CLUB DE GOLF LOS LEONES LAS CONDES - SANTIAGO - CHILE

SITE REPORT FOLLOWING VISIT IN JANUARY 2011

A D A M G O L F D E S I G N ARQUITECTOS DE CANCHAS DE GOLF

PROPOSED VIEW FROM THE LANDING AREA TOWARDS THE GREEN - HOLE N°1

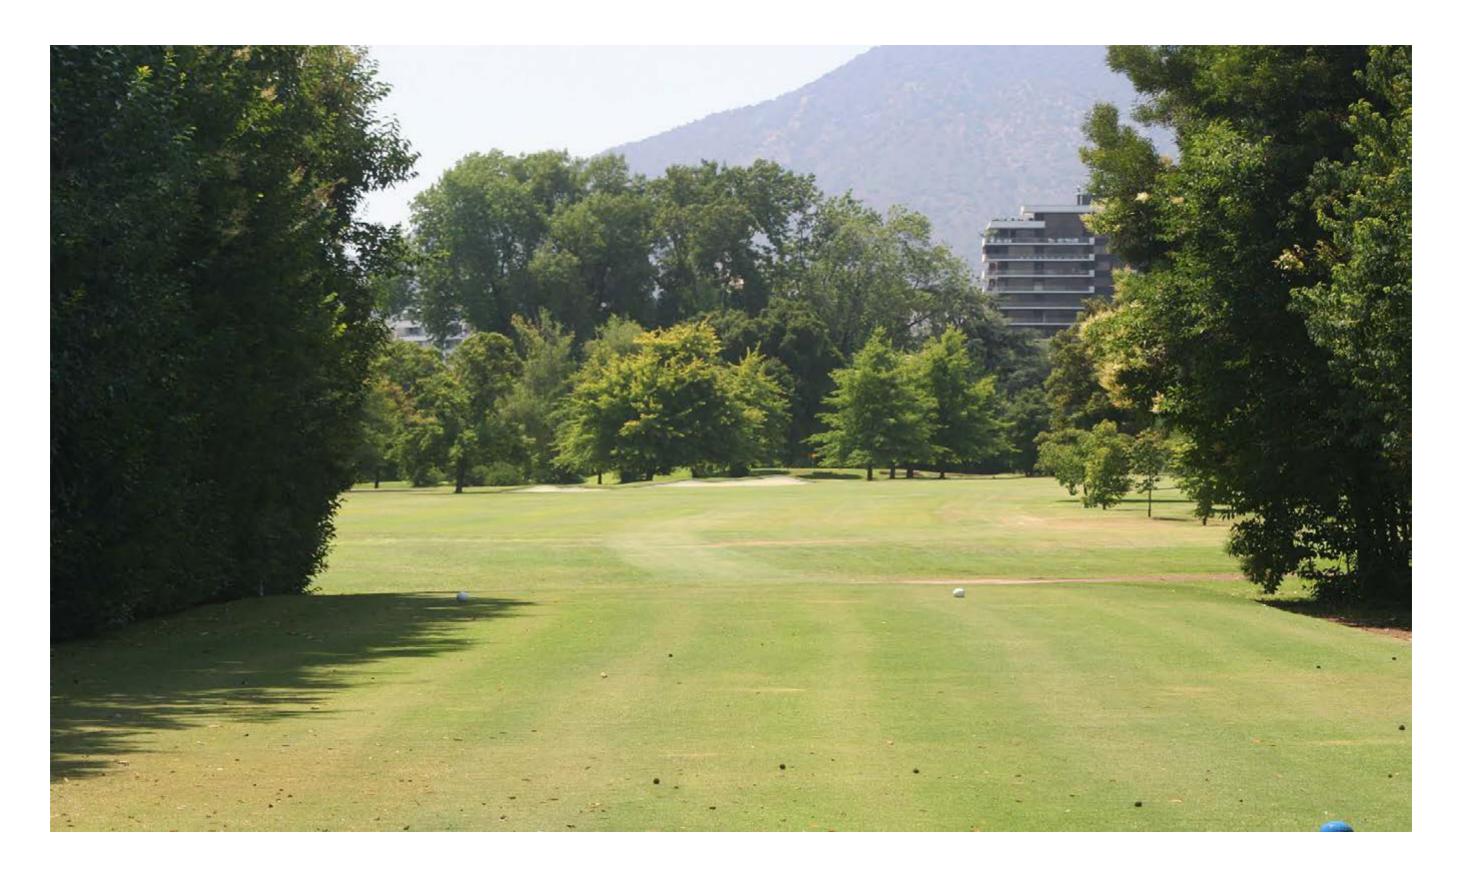
At present the left green bunker is barely visible and the lip is difficult to maintain. The 1st green bunker on the right is hardly visible and the lip is difficult to maintain. The 2nd green bunker on the right is completely blind.

We propose with the left green bunker to raise the sand line at the back right and to soften the slope of the existing wall by filling within the bunker. We also propose with the 1^{st} green bunker on the right to soften the existing wall into the bunker, to raise the sand line and remove the lip in front. The 2^{nd} green bunker on the right needs a lot of earth to become visible. Several options are possible. Leave it as is. Convert the bunker into a grass bunker or make the necessary earth movements to make the bunker visible.

PROPOSED VIEW FROM THE BACK TEE - HOLE $N\,^{\circ}\,2$

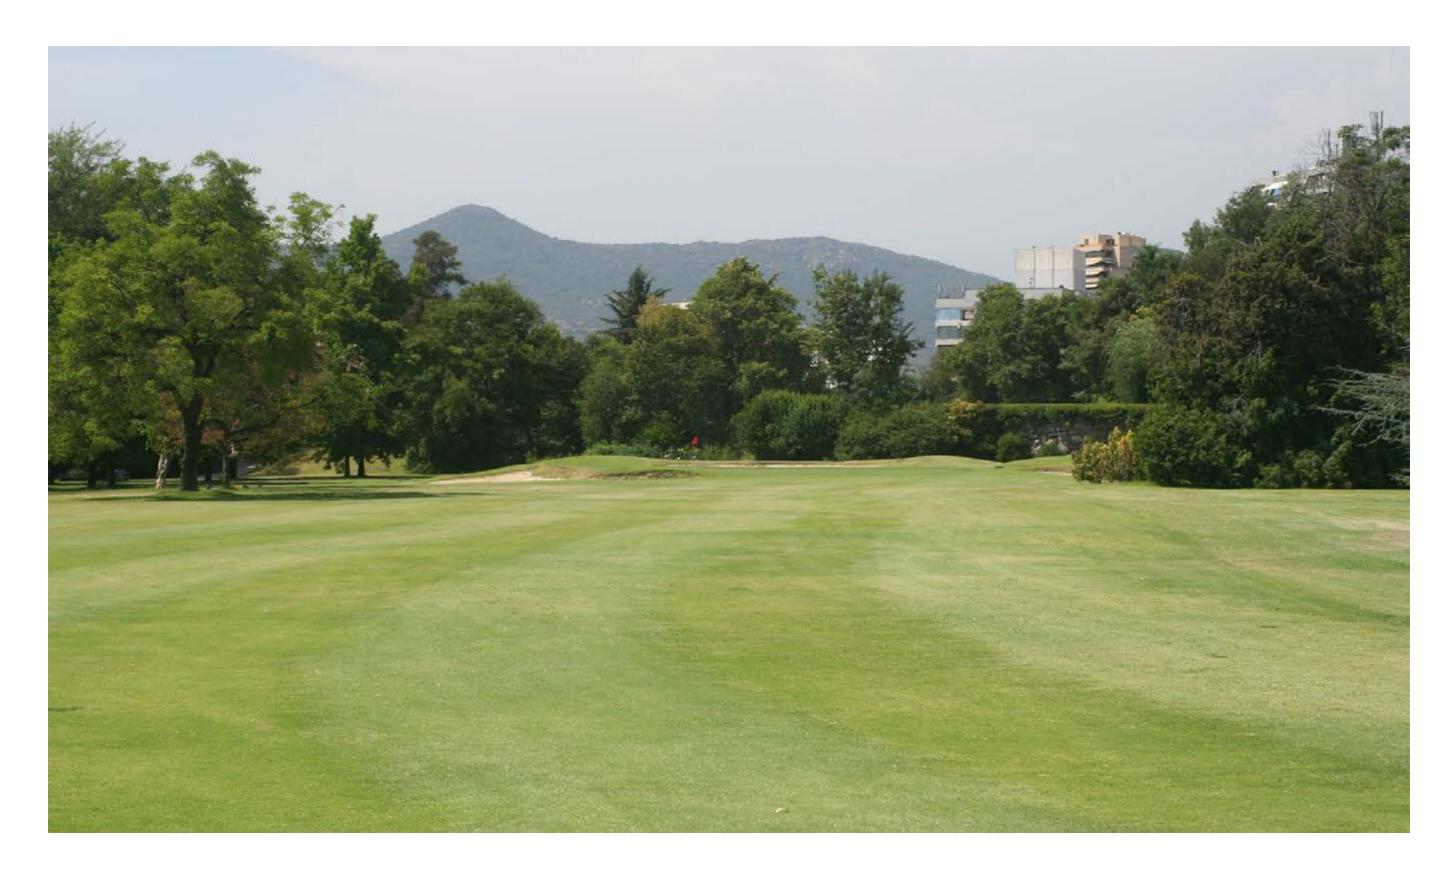
At present the fairway bunkers on the left side of the fairway are barely visible. Some players are slicing the ball over the corner of the dog-leg to get extra length.

We propose to elevate the mounding behind the fairway bunkers that will make the lip and the bunkers themselves more visible. As some players are slicing the ball over the corner of the dog-leg to get extra length, we looked at placing a bunker on the right in the semi-rough after the dog leg point. We concluded that this would be counter productive as the bunker itself wouldn't be visible from the tee, and that in due course the newly planted trees will grow to a sufficient size to be hazardous for the players.

EXISTING VIEW FROM THE TEE - HOLE N°4

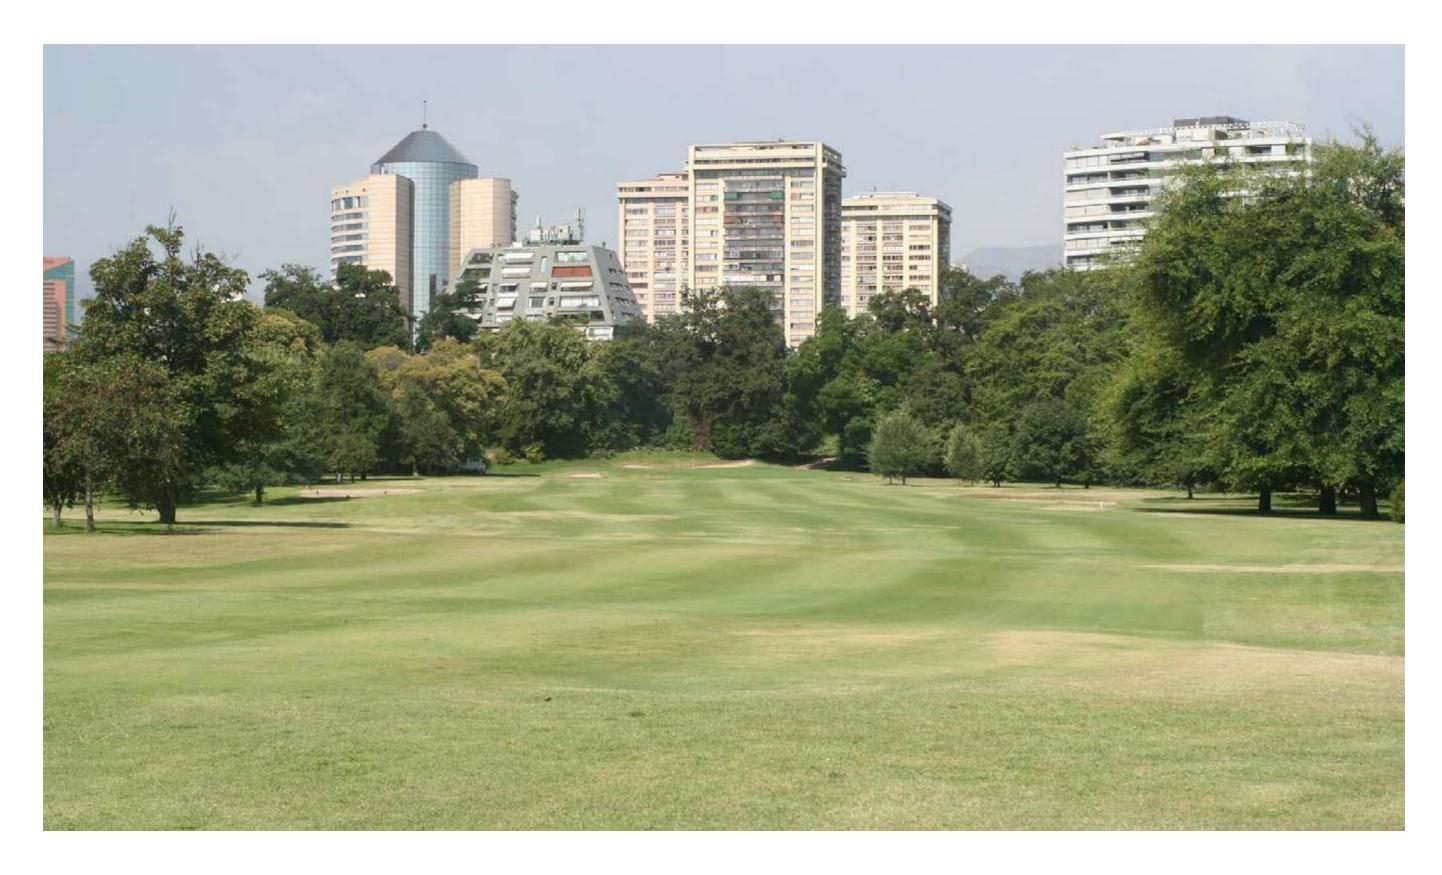
At present the two fairway bunkers are not penal enough and therefore lose in their strategic value. The vegetation needs to be reinforced along the road at the second landing area to improve safety. We should also look at the possibility of making the green bunker of the right more visible.

We propose to have more of a lip on the two fairway bunkers, so that they are more visible and more penal, the object being that a player in the bunker looses so to speak half a stroke. We would reduce the size of the 1st fairway bunker and create the slope for the lip within. We propose to reinforce the vegetation with more planting along the road at the second landing area to improve safety. We think that seeing ways of making the green bunker on the right more visible should be considered, also to improve safety.

PROPOSED VIEW OF THE LANDING AREA - HOLE N°5

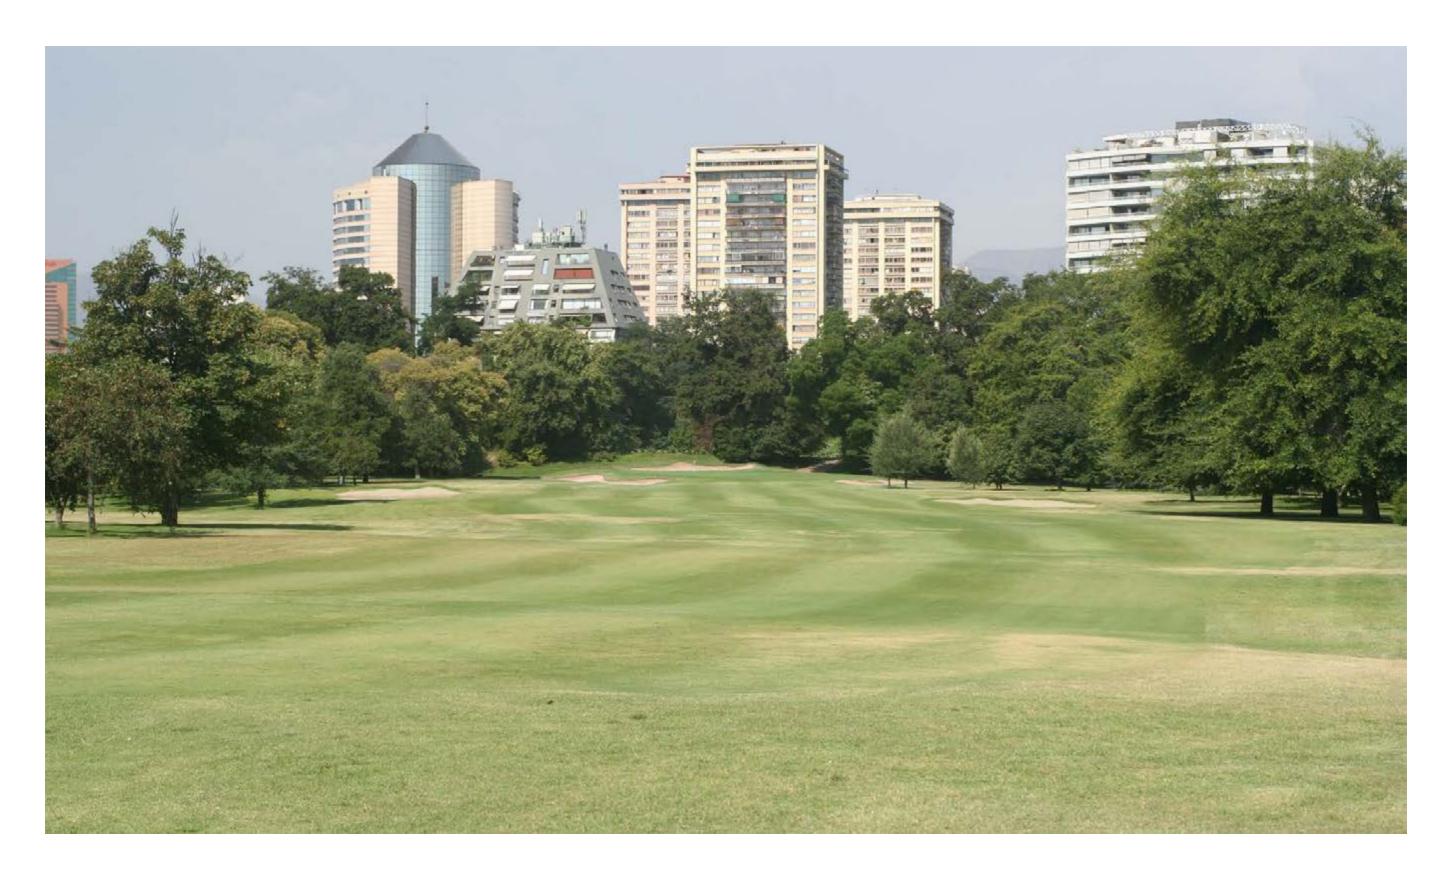
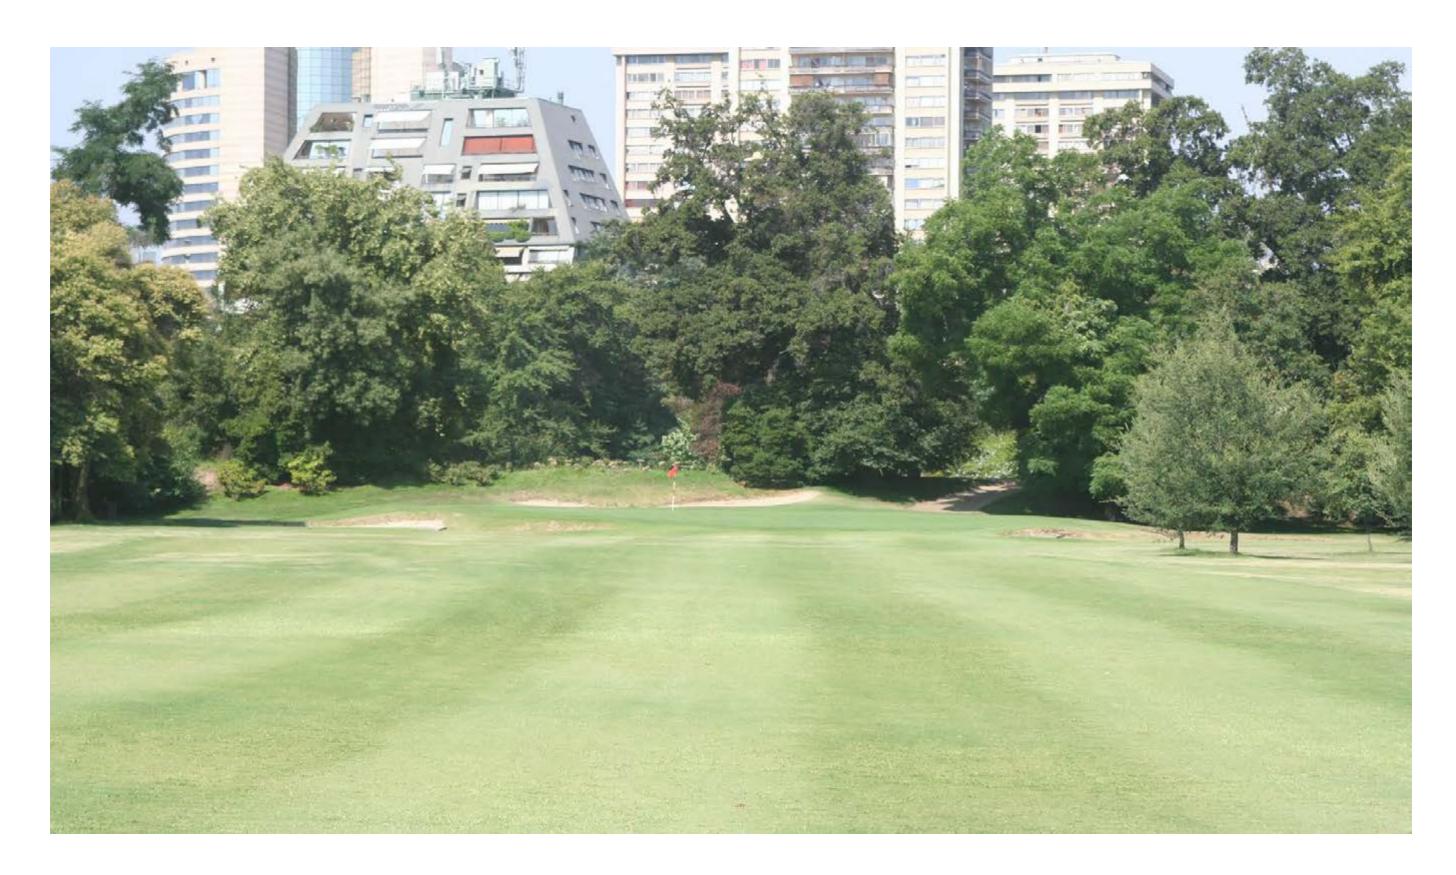
At present the fairway bunkers are not visible even though they are in play for the vast majority of players.

We propose to make the existing fairway bunkers more visible by placing some mounding behind the bunkers that will then allow us to raise the lip and sand line. They are in play for the majority of players so they should be clearly visible to have strategic value.

PROPOSED VIEW OF THE GREEN AREA - HOLE $N\,^{\circ}\,5$

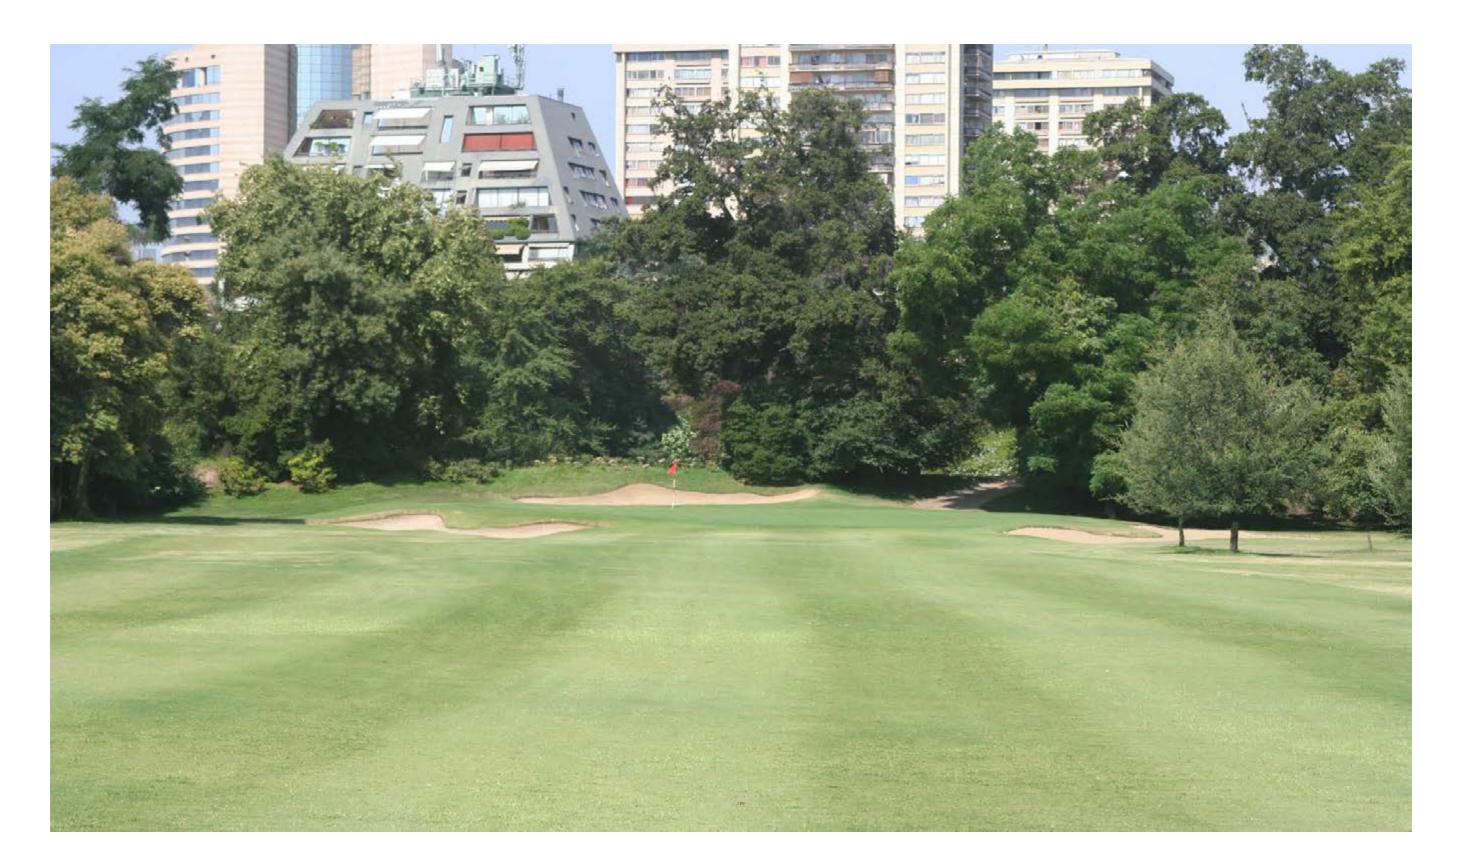
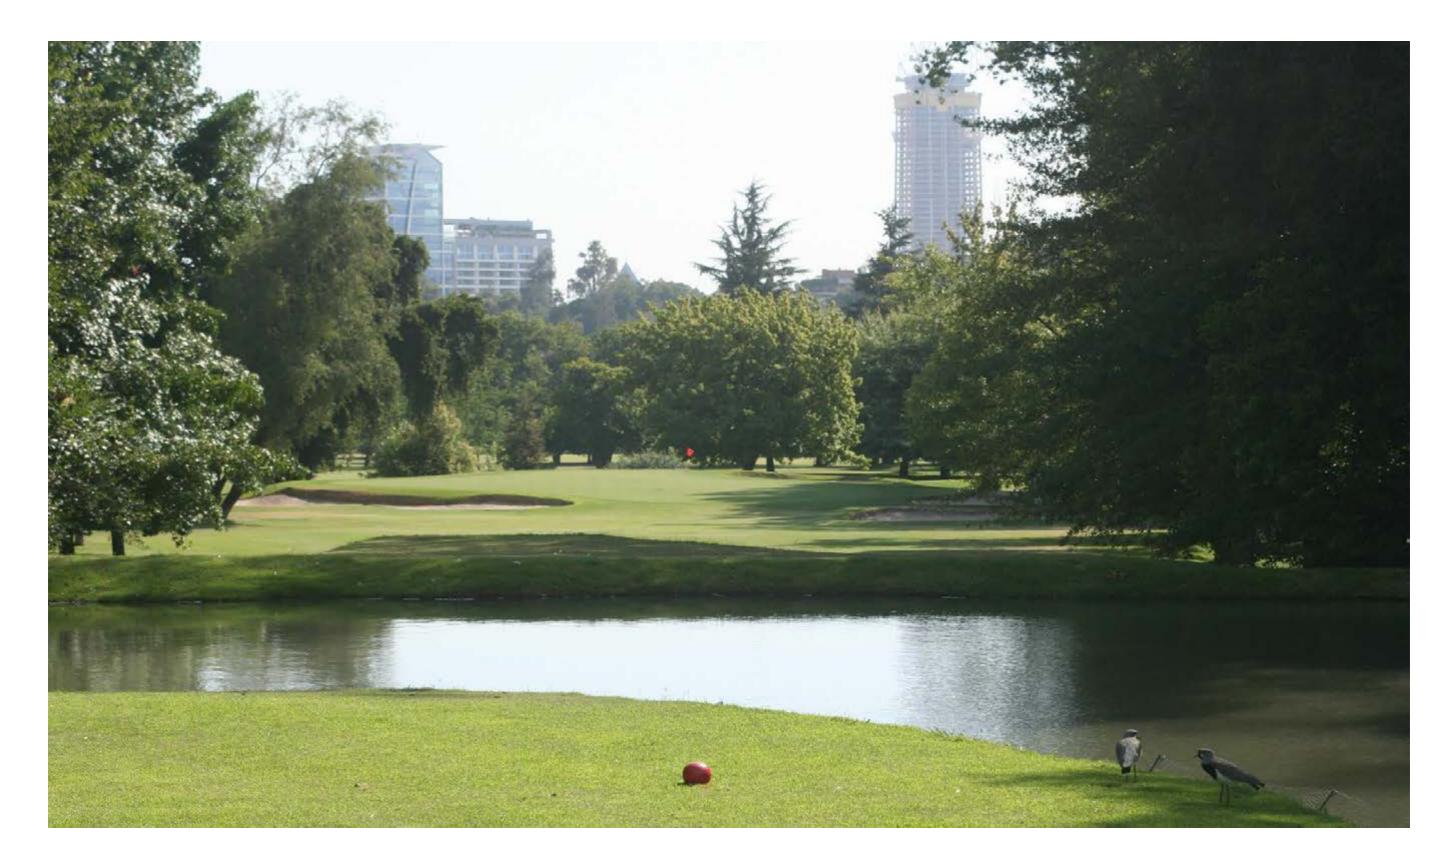
At present the left green bunker and the right green bunker need to be made more visible. The back green bunker lacks definition.

We propose to make the right green bunker and left green bunker more visible by lowering the front lip and raising the sand line. We also propose to prune the bottom branches of the trees before the green on the right so as to make the right green bunker more visible from the 1st landing area. We also propose to raise the sand line in the middle of the back green bunker to improve its visibility and to create a better visual composition of the green.
